Agenda Item **No. 5(c)**
Meeting of March 21, 2017

SUBJECT: Conditionally approving, pursuant to the Owner Participation Agreement with FOCIL-MB, LLC, a Schematic Design for Bayfront Park P22, a 5.5 acre park in Mission Bay South, that is within the scope of and adequately described in the Mission Bay Redevelopment Project approved under the Mission Bay Final Subsequent Environmental Impact Report, a Program EIR, and adopting environmental review findings pursuant to the California Environmental Quality Act; Mission Bay South Redevelopment Project Area

BAYFRONT PARK / MISSION BAY P22

COMBINED BASIC CONCEPT AND SCHEMATIC DESIGN SUBMITTAL
MARCH 21, 2017

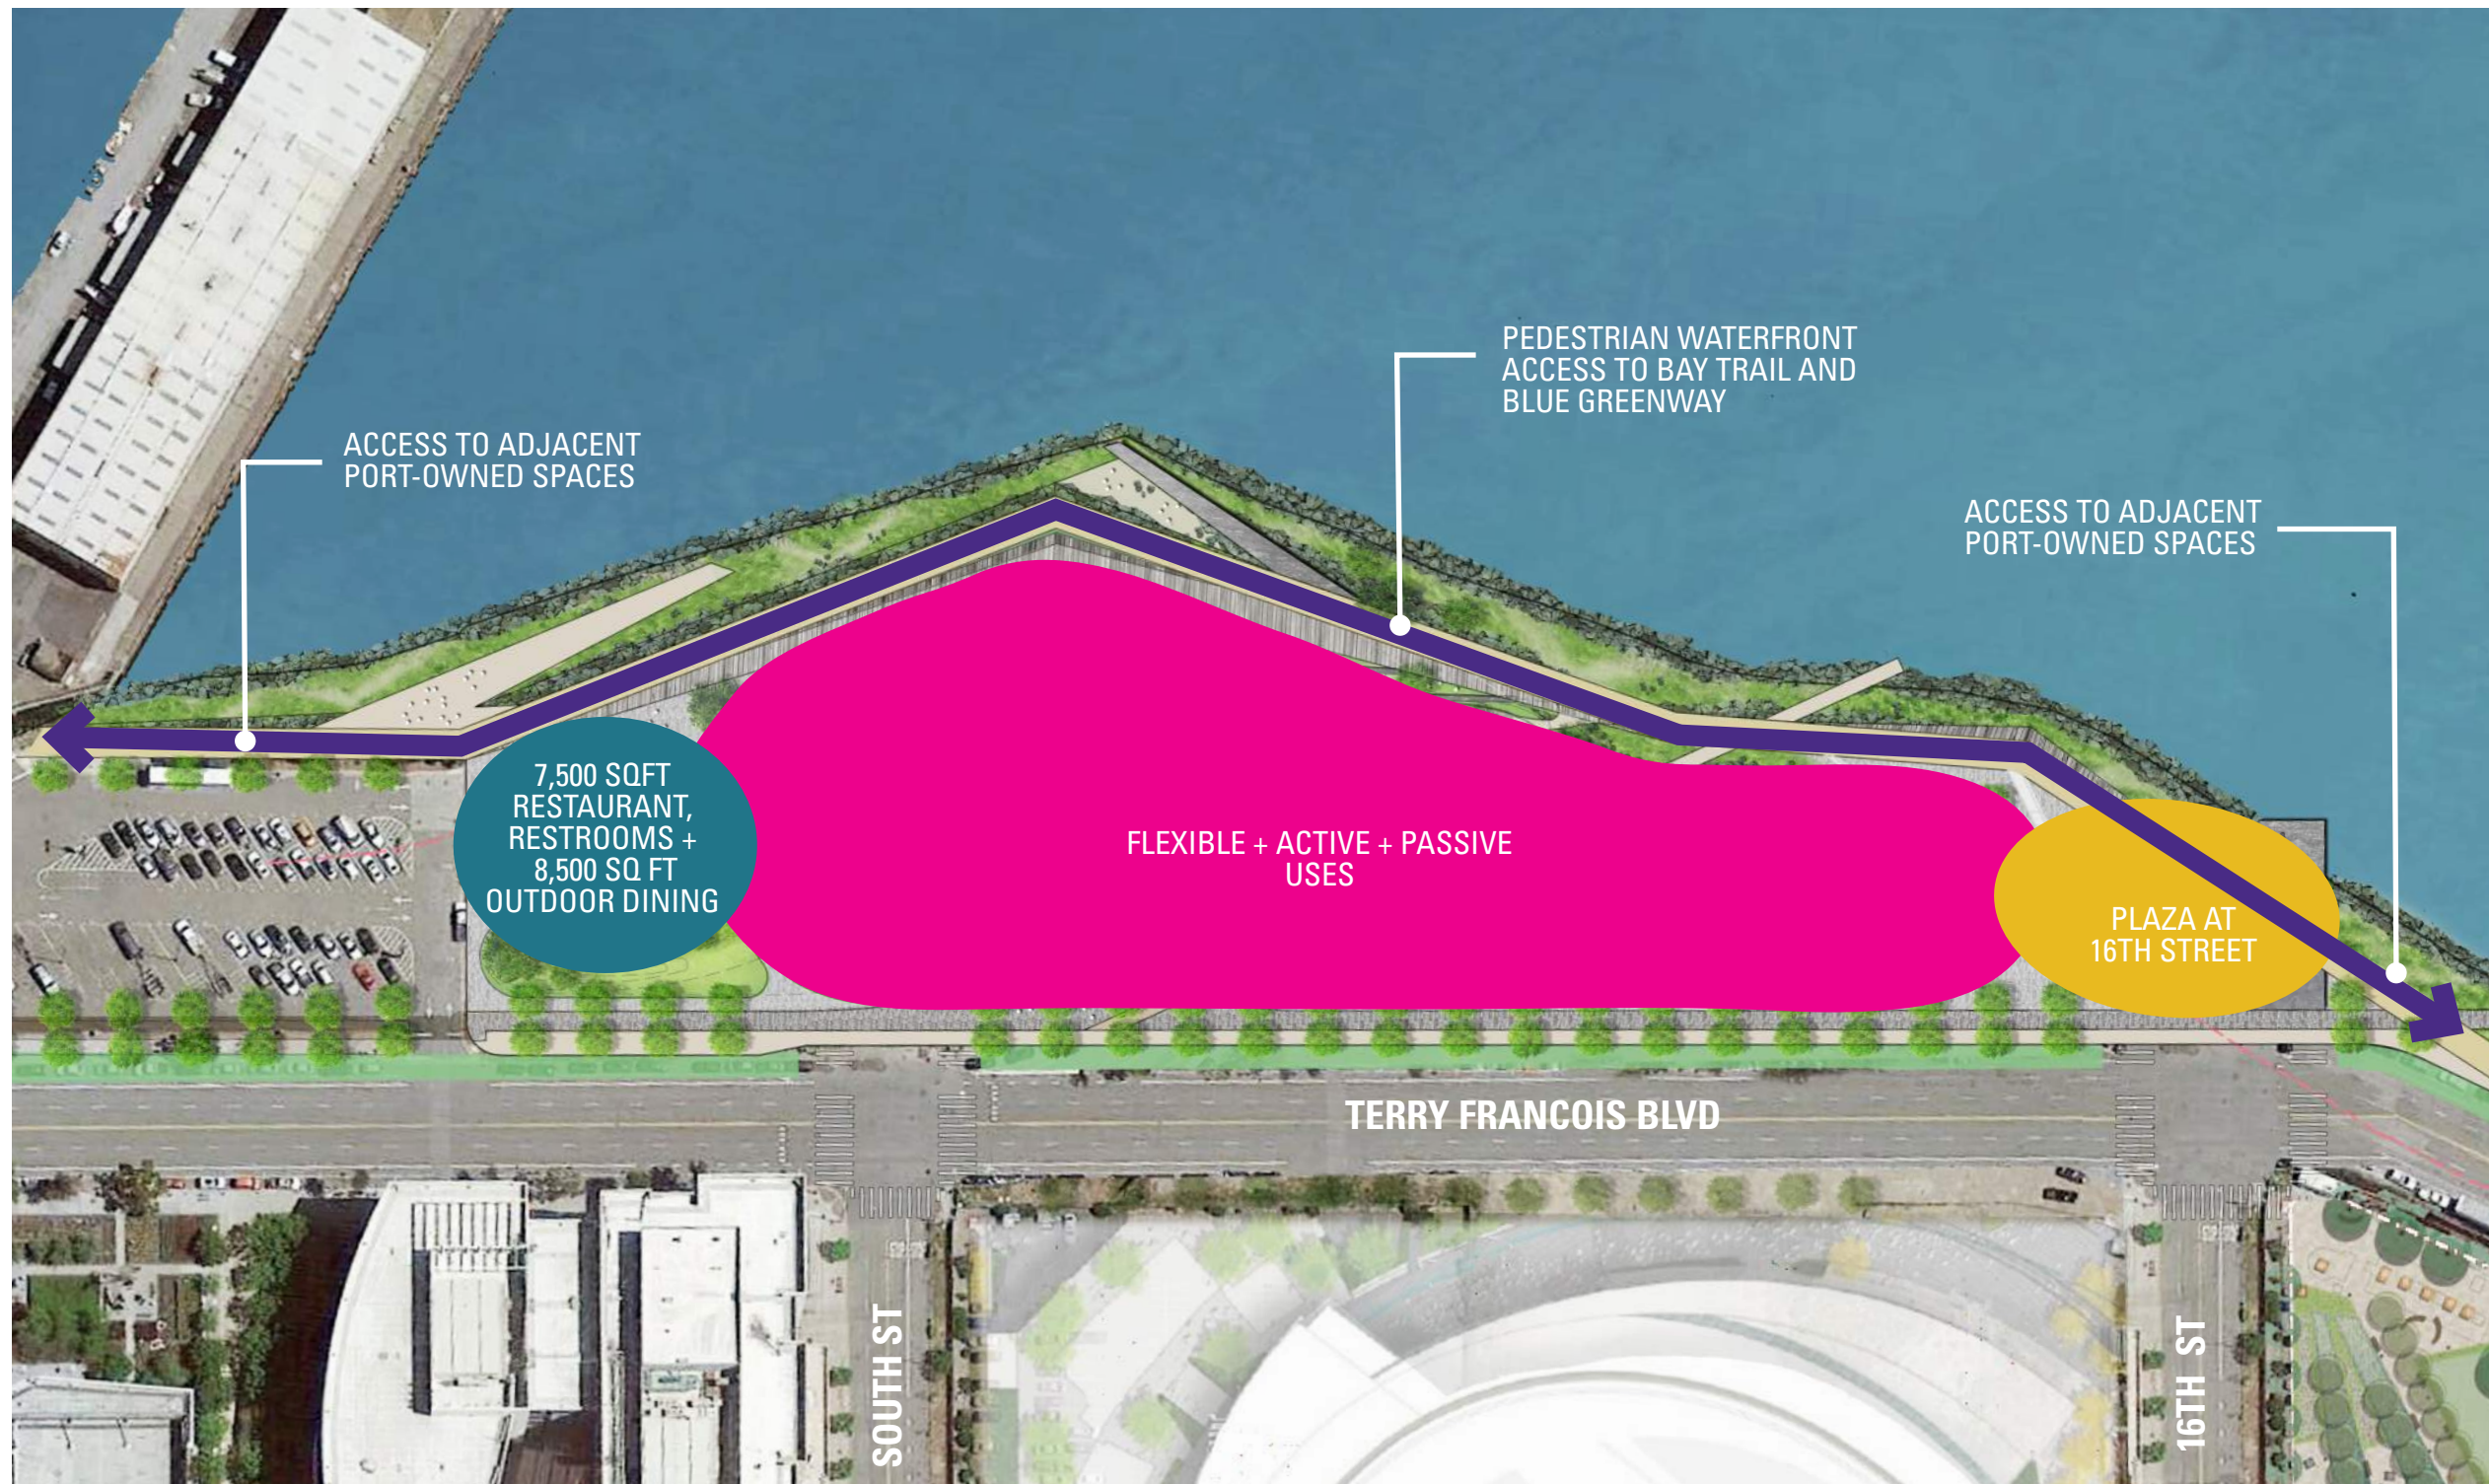
1. The Owner will further study the design of the 16th Street Plaza including landscaping and the Shade Pavilion by considering: a) the location, species and number of trees, to ensure an attractive and usable plaza and b) the relation of the Shade Pavilion to the mass and appearance of the Event Center on Blocks 29-32.

2. OCII staff will work with the Port on the design for the restaurant/café in Bayfront Park P22, including surrounding areas. The design shall include restrooms open to the general public and landscaping in order to achieve functional and visual integration between Bayfront Park P22 and the restaurant/café.
